RE: Haybarn Rehabilitation, Floyd Lamb Park at Tule Springs, 9200 Tule Springs Road, Las Vegas, Clark County, Nevada.

This is a response to the Nevada State Historic Preservation Office, (SHPO), comment and recommendations letter received by the City of Las Vegas department of Planning for the above-mentioned project, dated April 14, 2020.

**Haybarn Rehabilitation:**

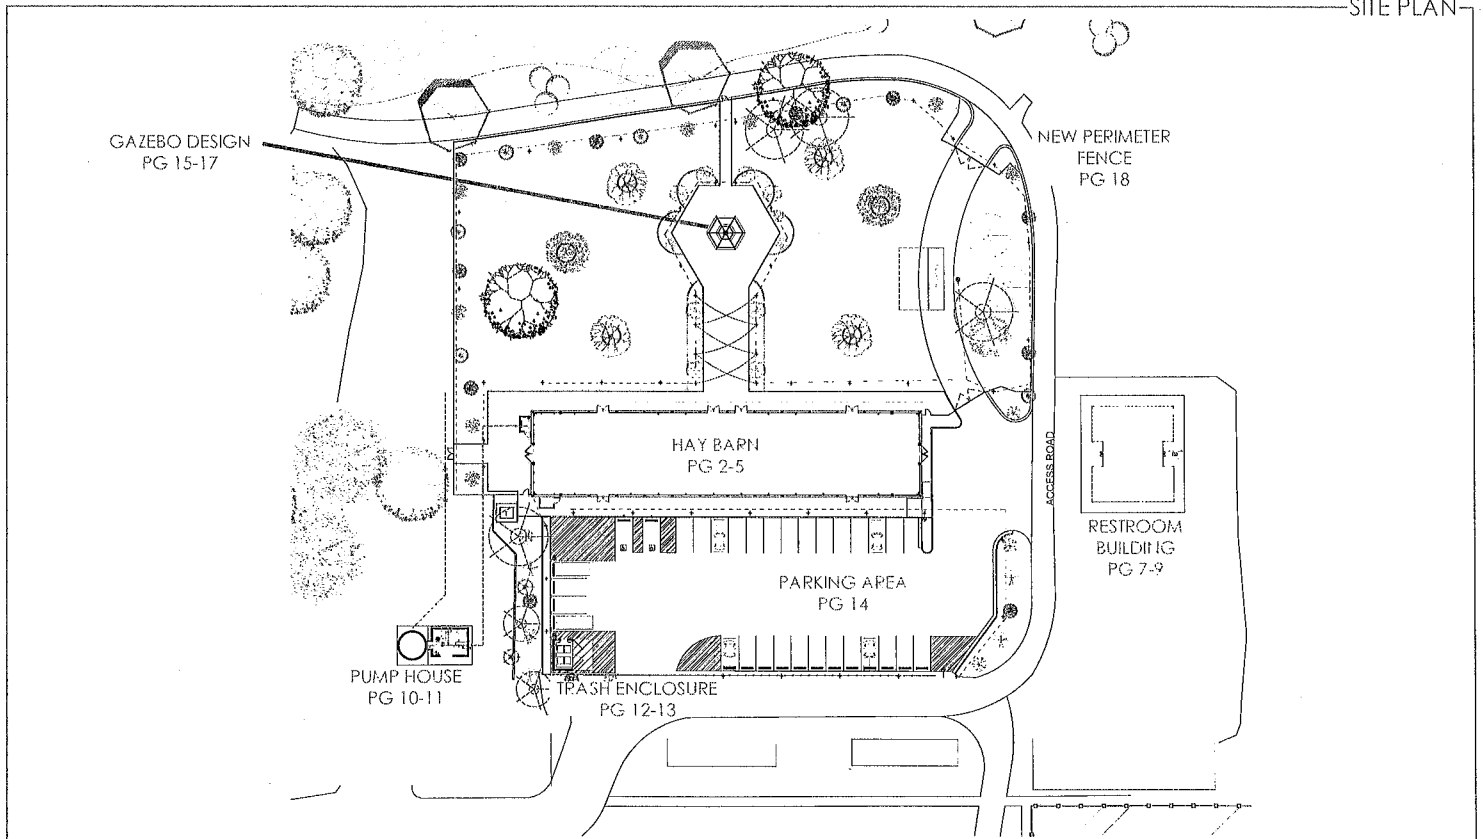
Site Lighting - Per your recommendations, we intend to install the industrial -style lighting fixture. See revised presentation documents with updated renderings.

HAY BARN - FLOOR PLAN

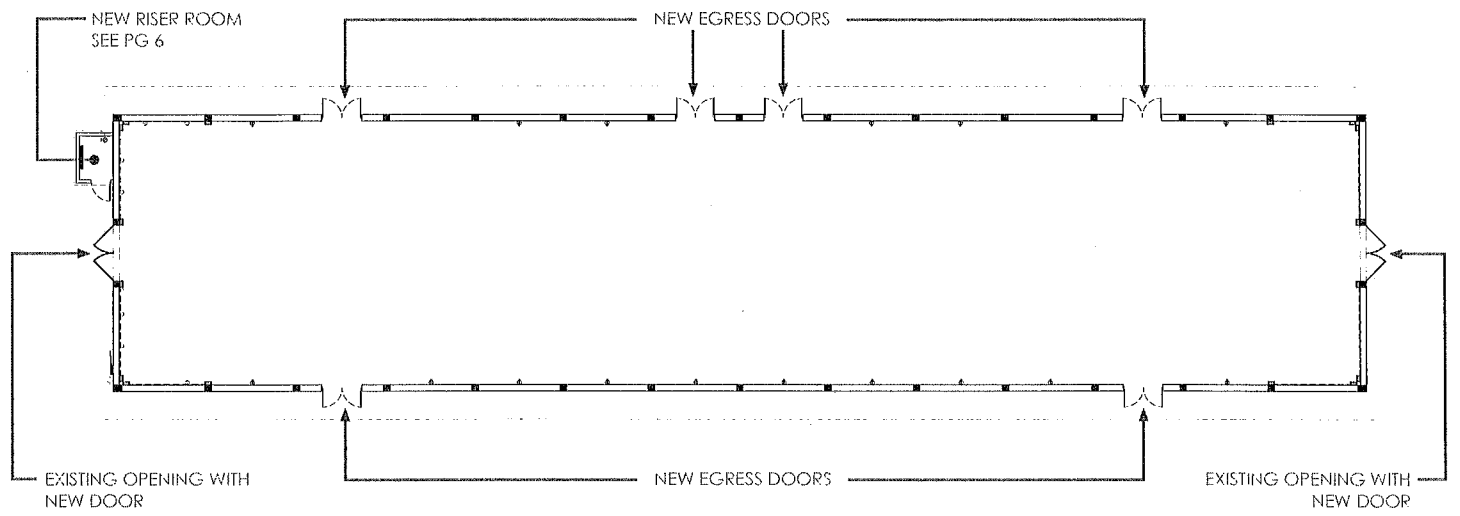
Fire Riser Room - Per your recommendations, the fire riser room will be located on the West elevation of the Haybarn as recommended by your review letter, see the attached revised plan. The fire riser room will be constructed from masonry block material to match the Haybarn in color. The Height of this room will not exceed the 8'-0" existing bond beam openings of the Haybarn. There are no posts or raised roof for the Fire Riser room, your review letter appears to be describing the separate Pump House design, which is located away from the Haybarn building and will sit adjacent to the proposed water supply tank and can be screened by vegetation as suggested. See revised presentation documents with updated renderings.

CURRENT FENCE

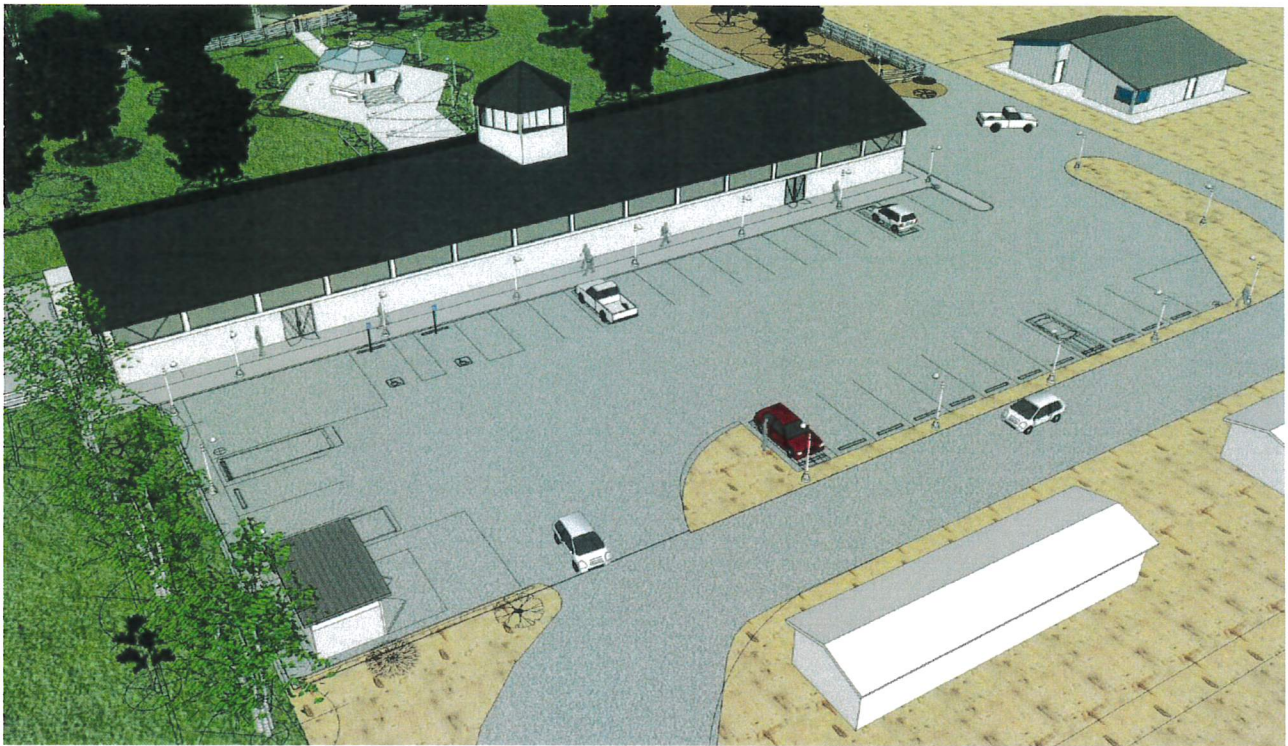
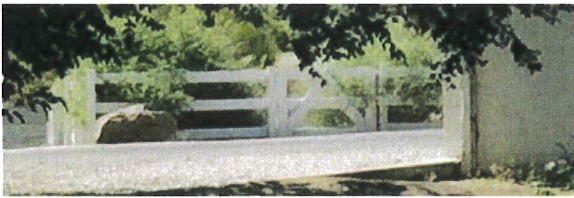
Site Fence Design - Per your recommendations, we intend to install fencing for the rear yard that matches the existing split rail fencing that occurs throughout the park. See updated presentation documents with updated renderings.
